Letter 54

PARKMERCED  
San Francisco, California

Attn: Mr. Bill Wycko Environmental Review Officer  
San Francisco Planning Department  
1650 Mission St. Suite 400 S.F., CA 94103

# DEVELOPMENT PHASES

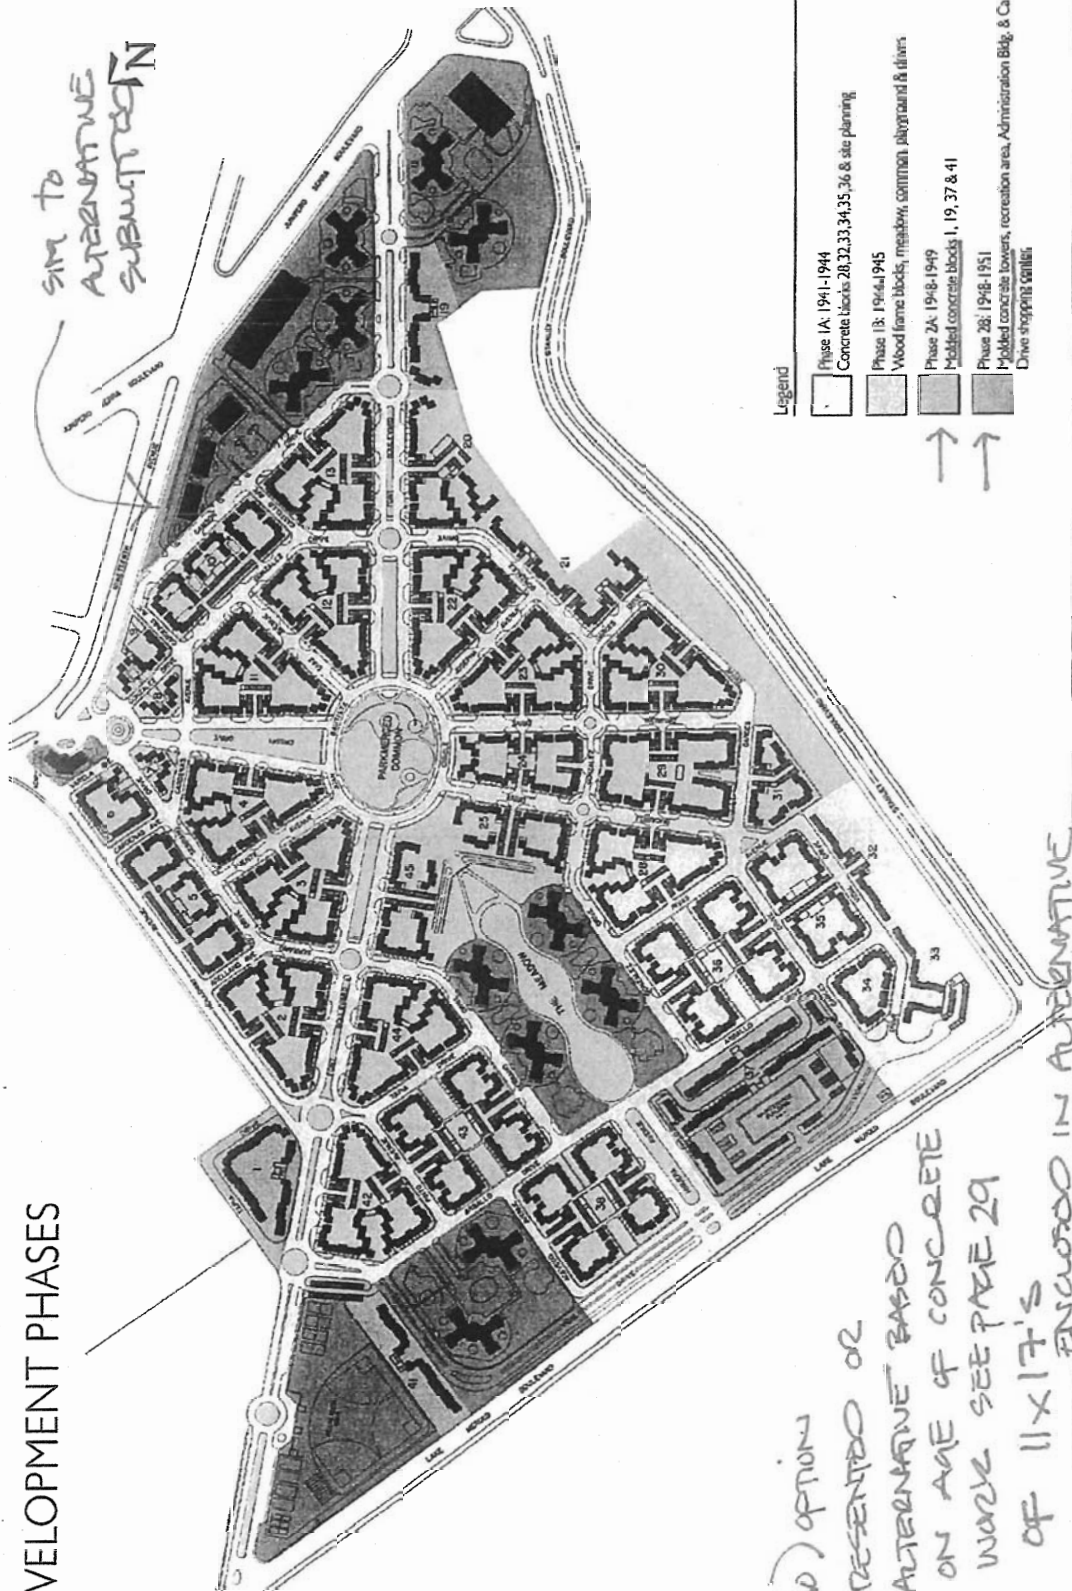
SHOWS ACCURATE THE "BUILT" AREA  
 TO OPEN/SPACE. NO INFO PROVIDED OR CALC'S.  
 OR DIAGRAMS THAT RE-AFFIRM THE LOSS.

The comment cites to a figure in the HRE and asserts that the figure inaccurately excludes interior courtyards between the garden apartments from open space calculations. The comment incorrectly identifies concrete drying racks and clothesline areas adjacent to laundry rooms as open space. Figure III.5: Existing Open Space Plan, in Chapter III, Project Description, p. III.13, correctly identifies all existing open space on the Project Site.

# OWNERSHIP

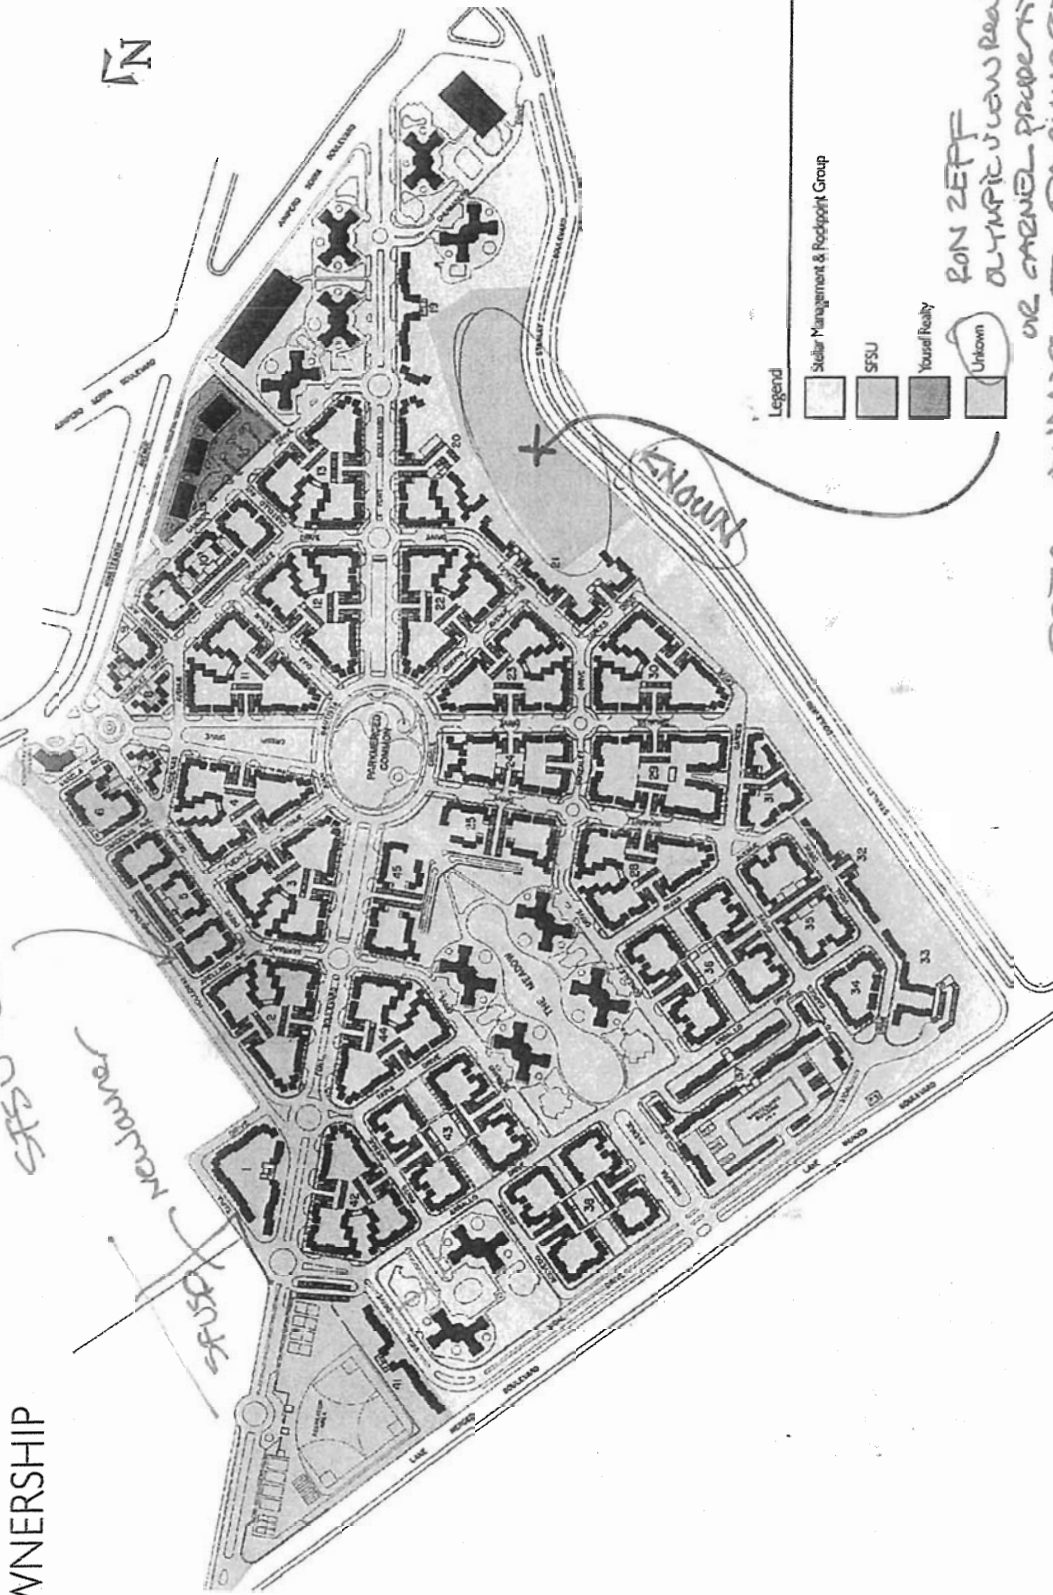
54.1.1  
con't

The comment cites to a figure and asserts that the figure inaccurately excludes off site properties, those which were part of the original Parkmerced boundary, as well as interior courtyards between the garden apartments from open space calculations. Please refer to Response TR.7.3 for a discussion on this topic. The comment incorrectly identifies concrete drying racks and clothesline areas adjacent to laundry rooms as open space. Figure III.5: Existing Open Space Plan, in Chapter III, Project Description, p. III.13, correctly identifies all existing open space on the Project Site.
